PRODUCT UPDATE

WF10499, WF10500 and WF10568 Fuel Filter Update

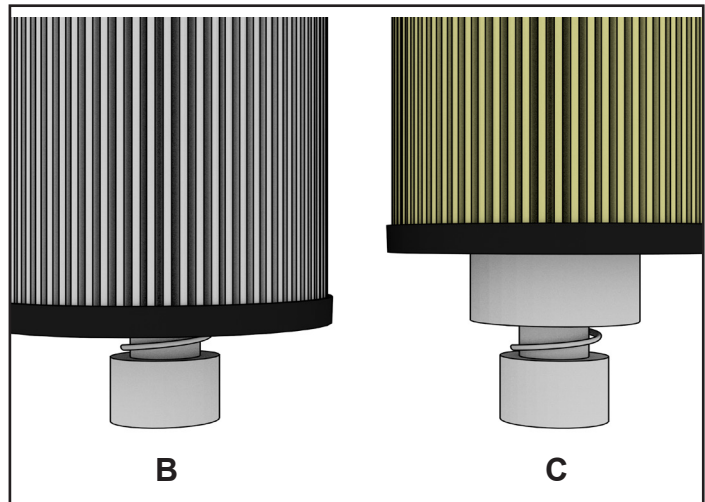
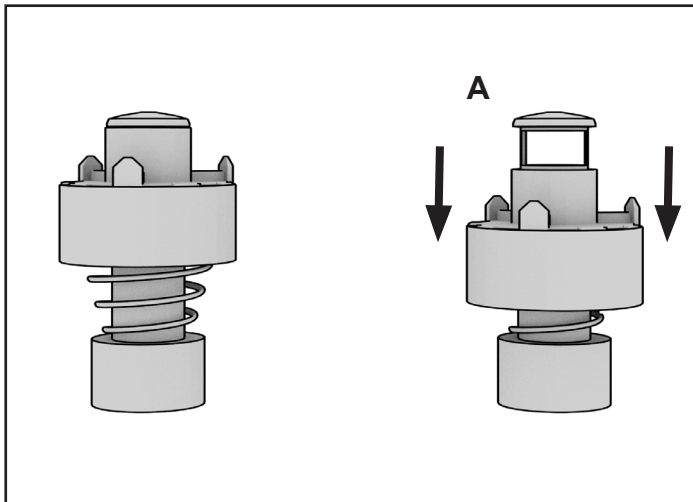
Improvement in filter media efficiency has resulted in a design change for the WIX WF10499, WF10500, and WF10568 fuel filters. When installed, the improved filter design engages the fuel head post at the top of the valve (C). As a result, the new filters have a reduced overall height. The WIX WF10499, WF10500 and WF10568 filters continue to fit, function, and provide excellent fuel filtration in all cataloged applications.

When the filter is engaged, the fuel valve is in the open position. (A)

The OES filter seals over the fuel valve (B). The WIX filter seals at the top of the fuel valve (C). Both filters open the fuel valve when installed.
